City of Alexandria, Virginia

MEMORANDUM

SUBJECT: 815½ KING STREET, BAR CASE #2011-00365

ISSUE: Partial Demolition/Encapsulation and Alterations
APPLICANT: 815 ½ King St LLC
LOCATION: 815 ½ King St
ZONE: KR / King Street urban retail

Figure 2. Proposed night view.

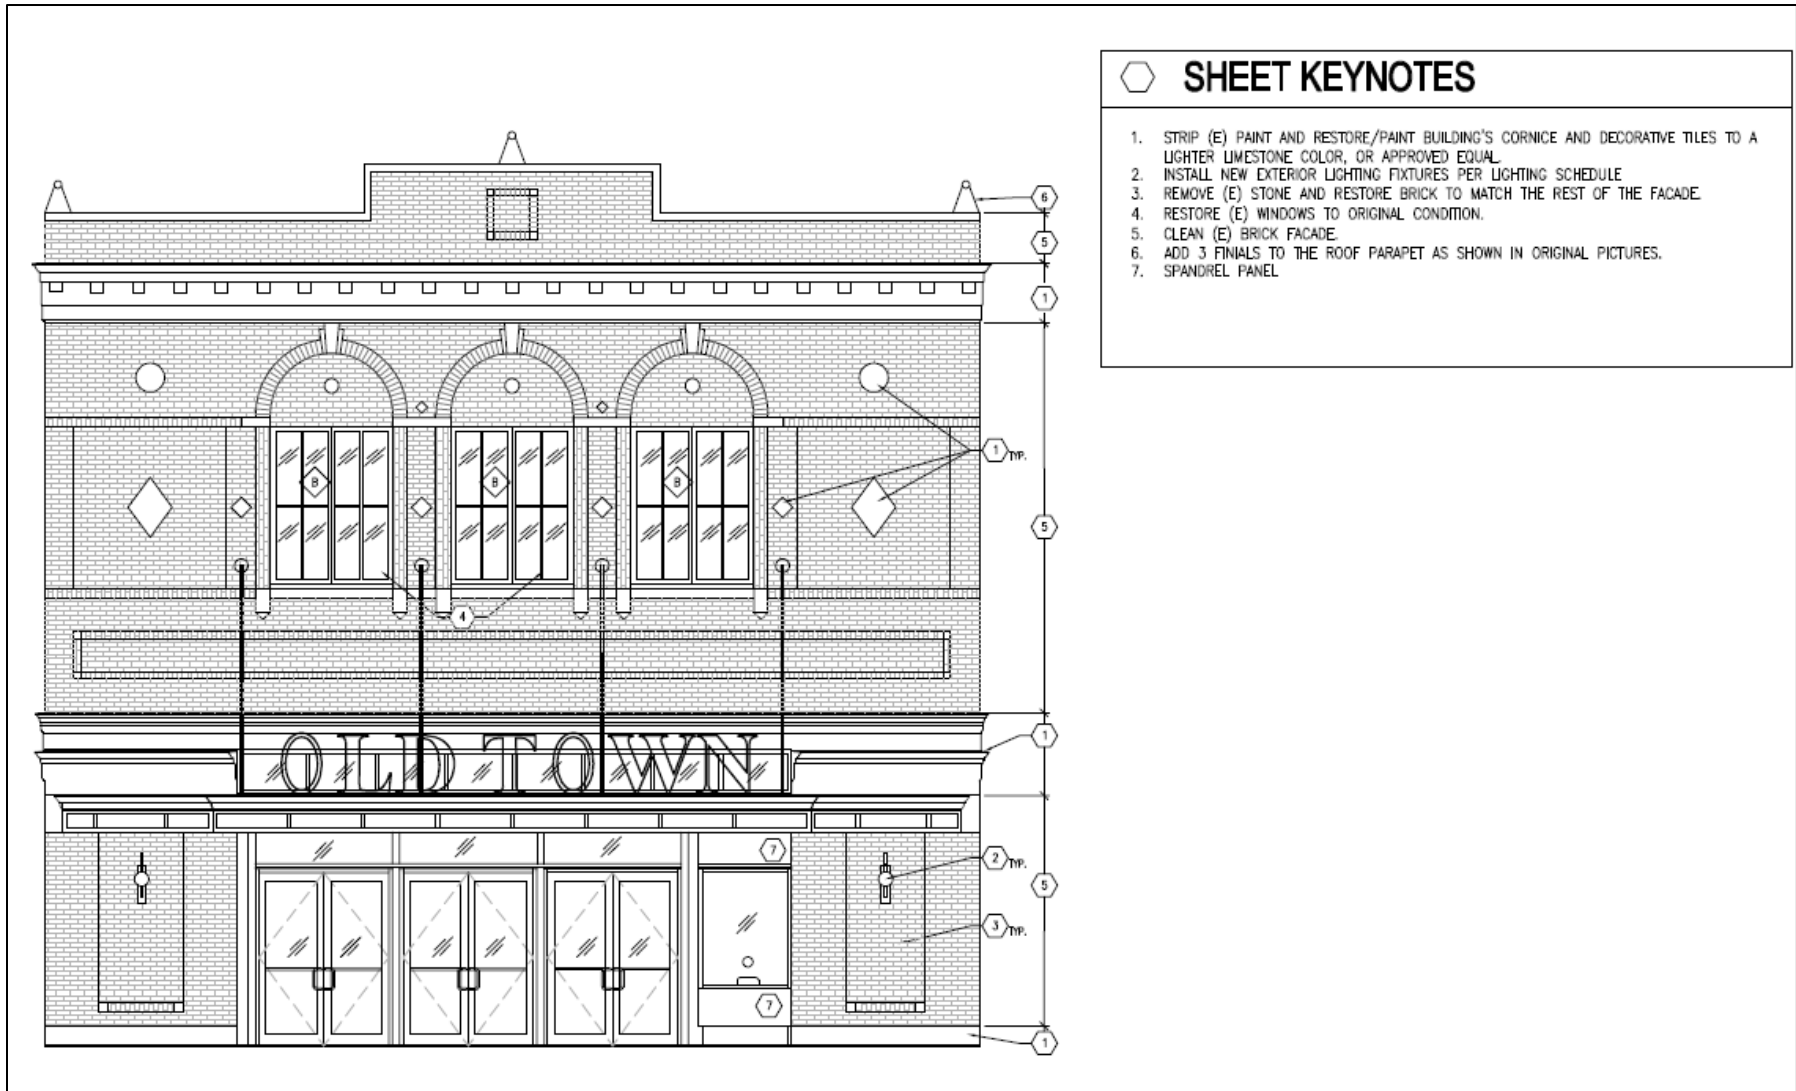
The proposed illumination on the marquee and above the movie posters is appropriate for the style and period of this building. While the *Design Guidelines* generally discourage windows with obscure glass, Staff supports this application to make the second story windows translucent, as they are currently partially blocked by mechanical equipment and framing. Illuminating the

interior of the second story behind these windows will provide a soft glow to animate the upper level of the façade at night when the theater is in operation.

Figure 3. Proposed facade (south elevation).

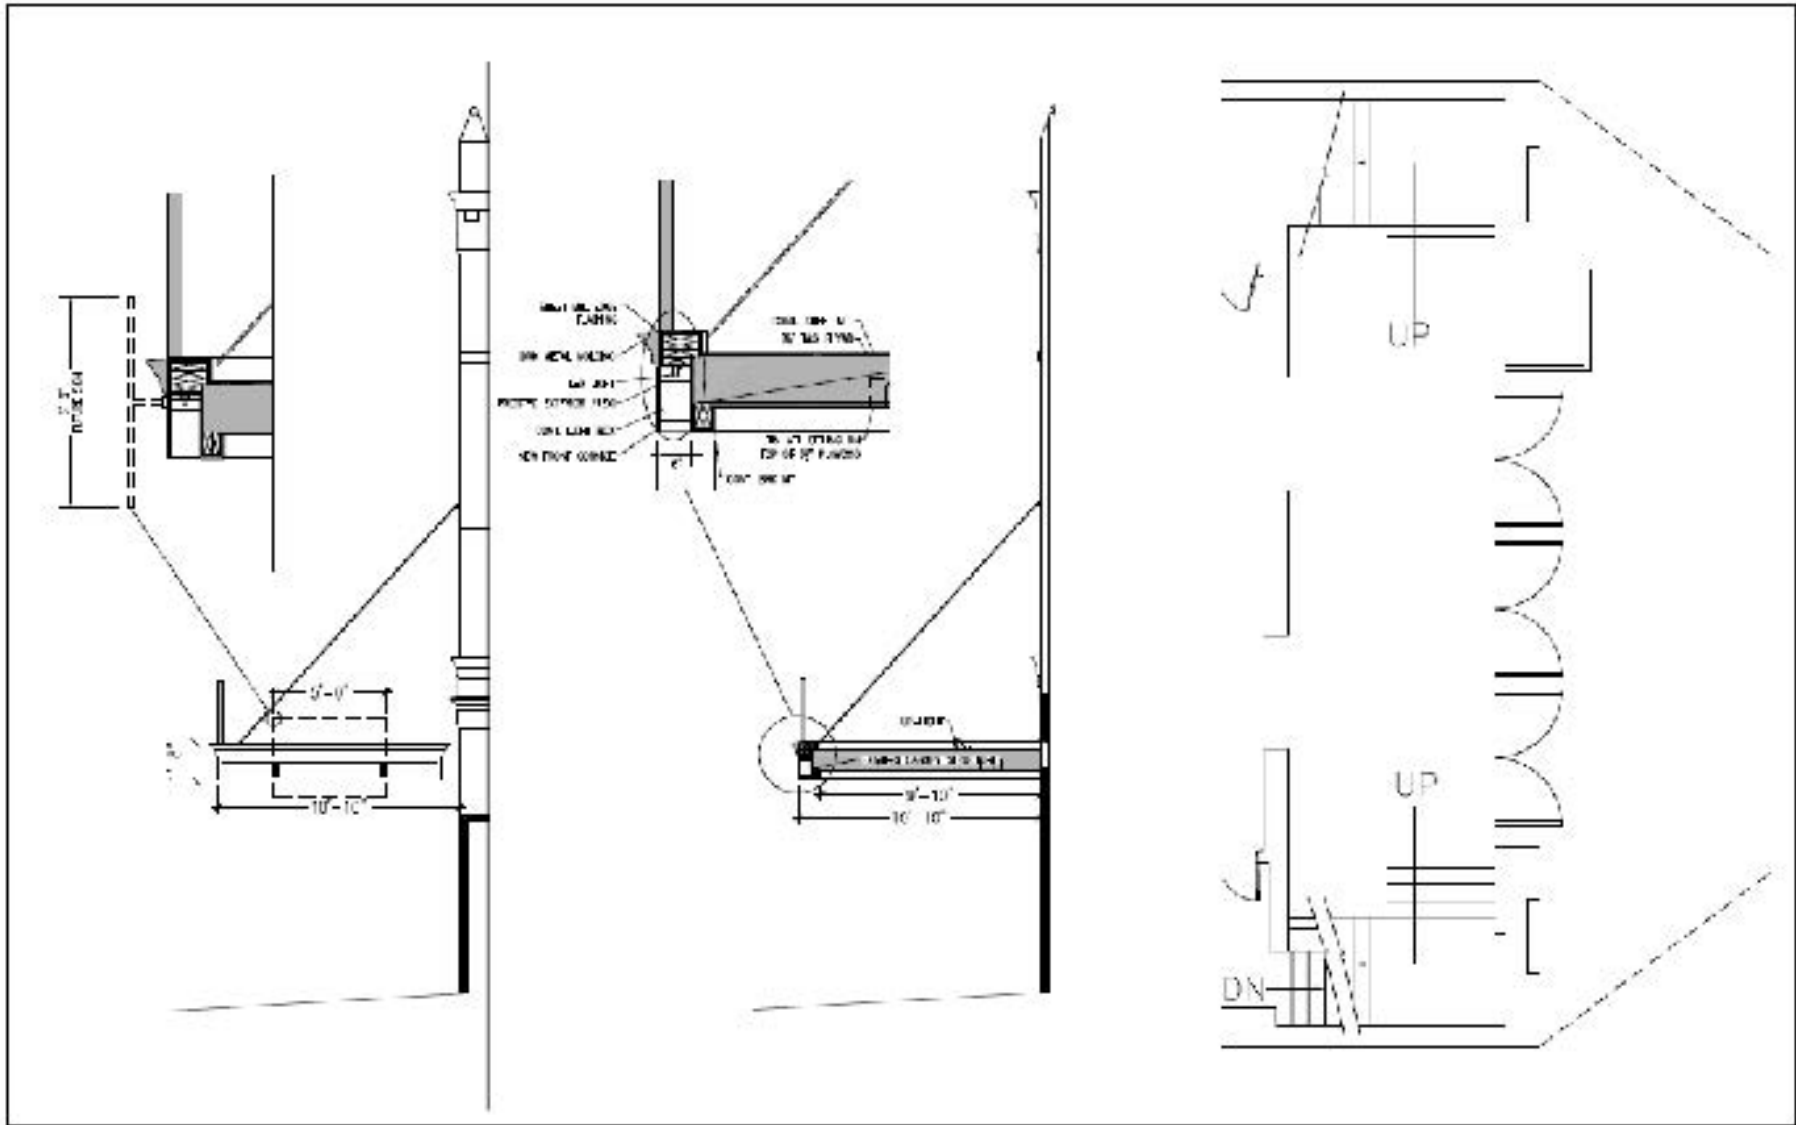
While it had been noted in the previous Staff report that the existing marquee is not suited to the first period of the building’s appearance, Staff believes that the refaced and repaired marquee will result in an appearance that appropriately represents much of the building’s life and has gained historic importance in its own right. Although the size will not change, the marquee will have less overwhelming signage due to the changes proposed to the “OLD TOWN” lettering and the reduction in size of the two movie identification signs. This will allow more of the building’s metal storefront cornice and period appropriate marquee fascia to be visible from the street. Staff commends the applicant for removing the oversized menu board signs and notes that the smaller signs are more proportionate to the scale of the marquee.

The proposed storefront system is similar to the existing, with multiple sets of double doors necessary for egress from a theater. The revised storefront reuses and re-faces the existing ticket booth and does not feature any type of show window, as previously proposed. The black metal system is understated and will coordinate with the black color of the refaced marquee and Old Town sign to provide a unified façade composition. Staff supports the proposal to reopen the transom just above the marquee, noting that the area proposed to be reopened was originally open as seen in the 1915 photograph, where the original entrance was recessed.

1. That this application serves as a sign master plan but that the future tenant submit an application before the BAR for final sign details;
2. That Staff approve the mortar and brick color and texture for any area requiring infill;
3. That if replacement windows are necessary on the front or rear elevation, that they be in conformance with the Board’s adopted Window Policy; and
4. That the applicant recreates the three finials and bracket molding at the roof parapet, shown in the original photographs, as part of the façade restoration.

Figure 6. Details of proposed storefront system.

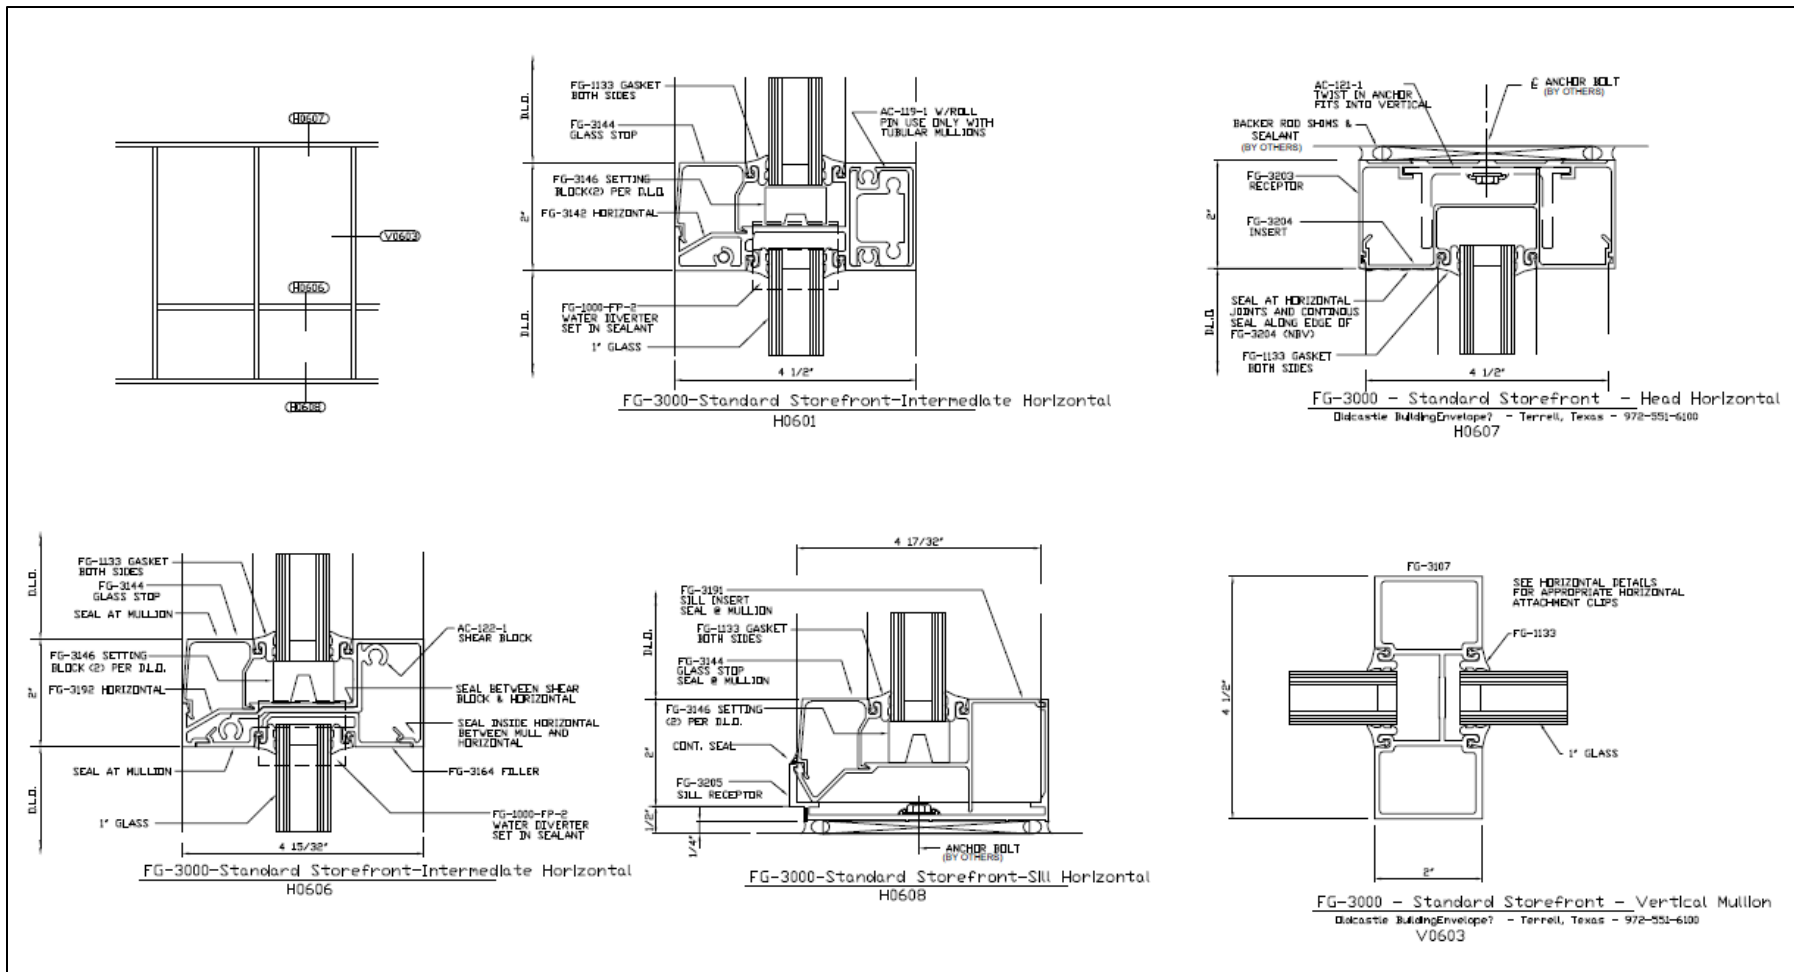
Staff finds the proposed scheme to be consistent with the King Street Retail Strategy *Storefront Design Guidelines* which advise “individual storefronts to follow the small-scale property pattern of King Street to add to the interest and richness of the pedestrian experience.” In addition, the *Storefront Guidelines* encourage “permanent marquee structures or canopies that project from the building...designed as an attractive and integral part of the overall façade design.”

Figure 1. Existing front (south) elevation.

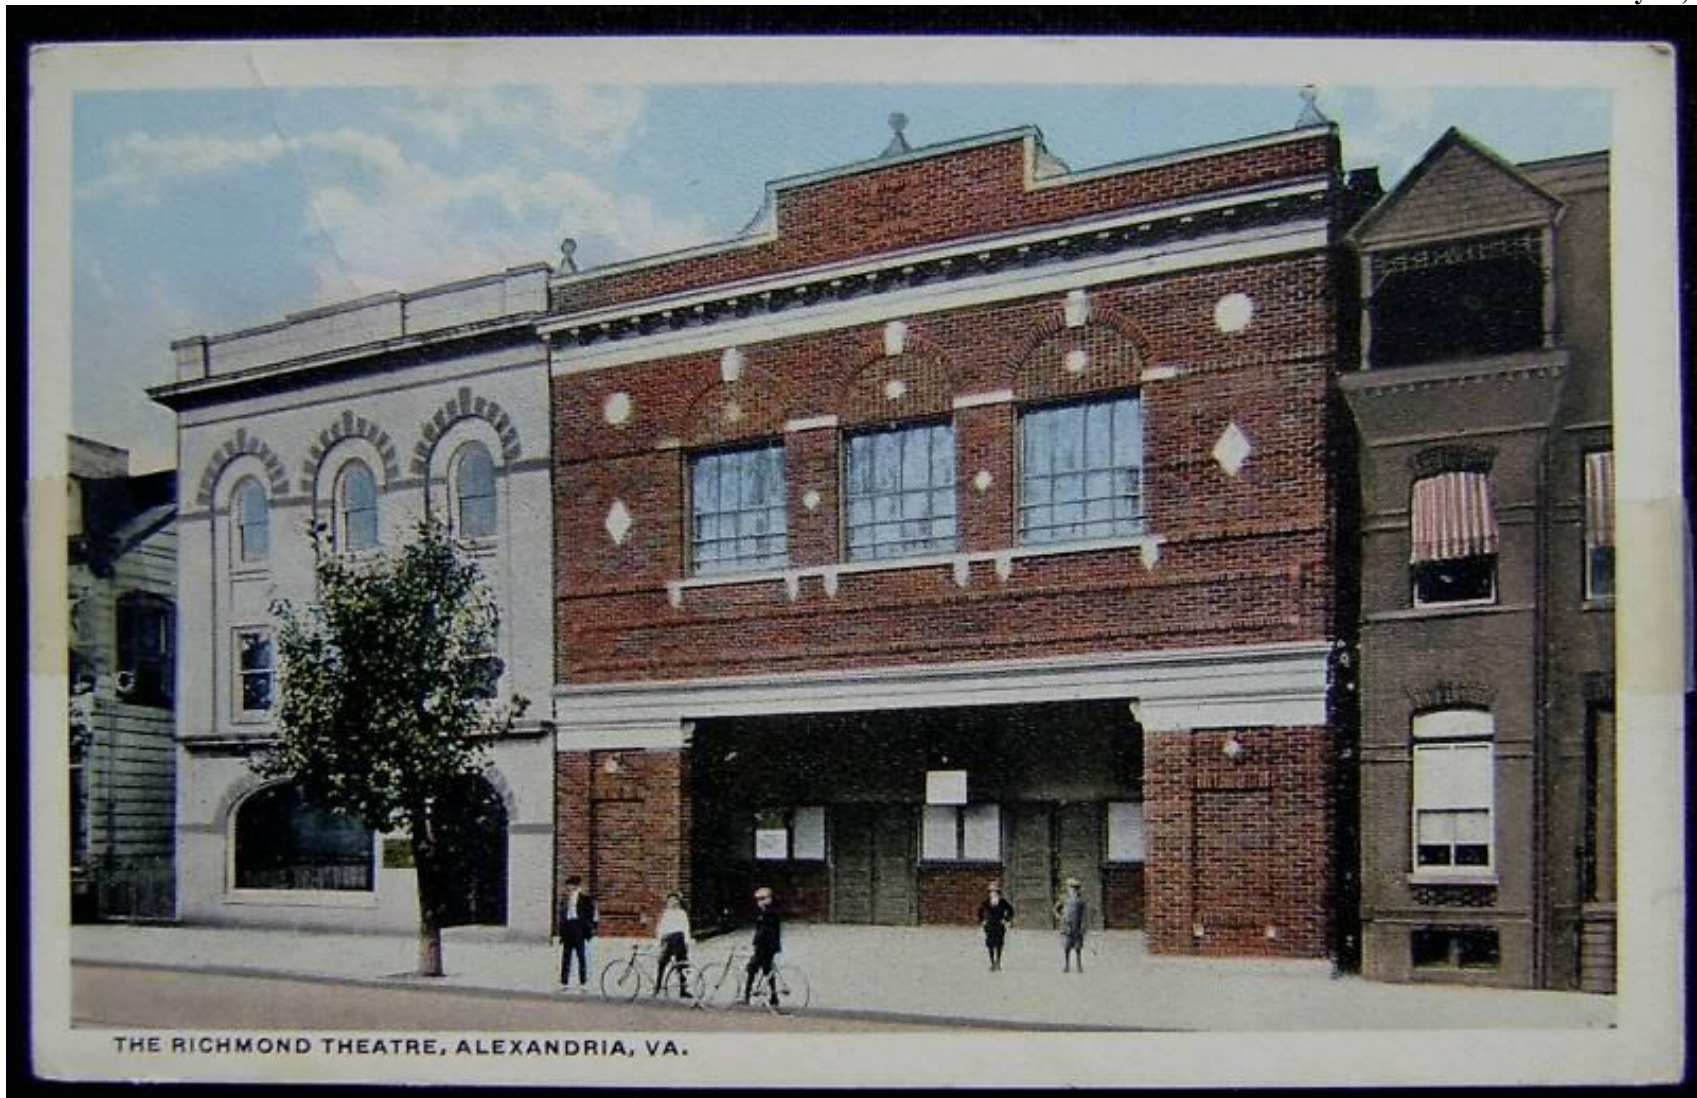
Staff finds that the existing modern marquee is out of scale and detracts from the historic architectural style and original character defining features of this building. The existing storefront system with pairs of double doors and a box office, as well as the display areas with terrazzo tile, are a more recent alteration with no historic significance and therefore Staff has no objection to removal of the existing marquee or first-floor storefront but recommends that the

Figure 6. Specifications for storefront system.

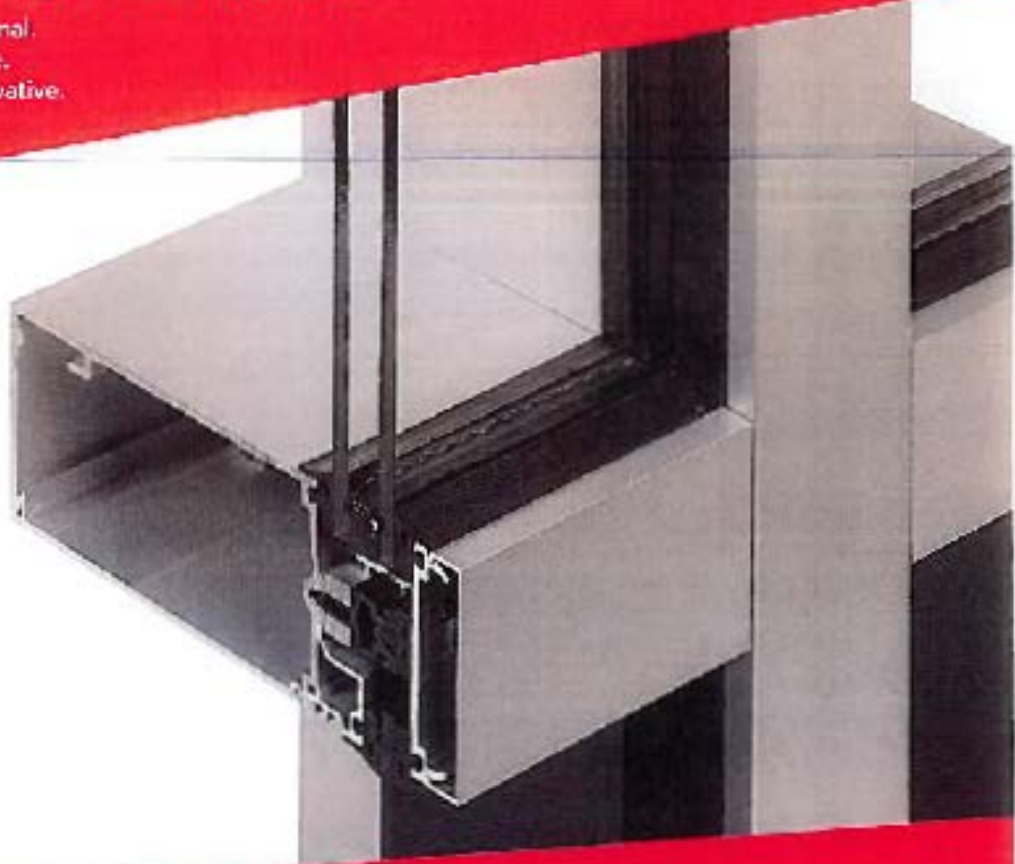
The applicant proposes to install a modern aluminum storefront system in place of the existing box office and entry. The new storefront will be in the same opening as the existing and historic opening so that the substantial brick piers on the sides will be uncovered and will remain. The historic first-story metal cornice will be retained and repaired. The applicant proposes to use a black anodized aluminum system with satin nickel hardware for the doors and windows. Staff finds this type of storefront to be appropriate for this building because, although it is clearly modern, it references the 1914 photograph and early metal storefronts common during the first half of the 20th-century. In addition, the character-defining cornice above the storefront will again be visually prominent. The modern storefront system also allows for a certain degree of flexibility with respect to the number and location of doors. The photo simulation shows three equal-sized openings that can be interchanged to allow for two sets of doors and one large window or one set of doors and two large windows. Because the tenant has not yet been determined, the applicant requests the flexibility to work with Staff to determine the final window and door arrangement within the framework of the proposed storefront system.
